Project Information		
Project Title:	Dig ditch from 24-	1-STX-10 to 24-AX-10 and reinstall electrical wire	Date:	12/20/2010
DOE Code:		<u> </u>	Contractor Code:	
Project Lead:	Marcus Bruckner			
Project Overview  1. Brief project description [include anything that could impact the environment]  2. Legal location  3. Duration of the project  4. Major equipment to be used		1 Dig ditch from 24-51-STX-10 to 24-AX-10 and remove 2. 24-51-STX-10 and 24-AX-10 (SW NW 10 TOWNSHIP 3. 1 day 4. Backhoe	·	(N 270')

# 24-AX-10 to 24-51-STX-10 Buried Powerline

# **NEPA Review Routing Form**

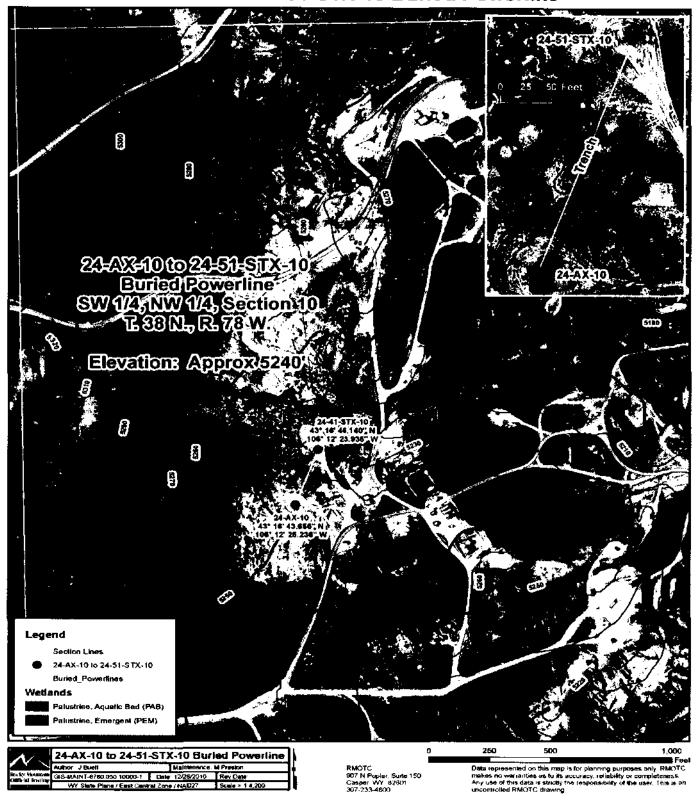
WELL PAD DISTURBANCE IS APPROX 125' FROM EACH WELL BORE.

THIS CONSTRUCTION INVOLUES DISTURBANCE OF APPROX

20' BETWEEN THE TWO WELL PADS. THE PROBABILITY OF INTERSECTING CULTURAL RESOURCES IN THIS HIGH TRAFFIC AREA IS EXTREMELY UNLIKELY.
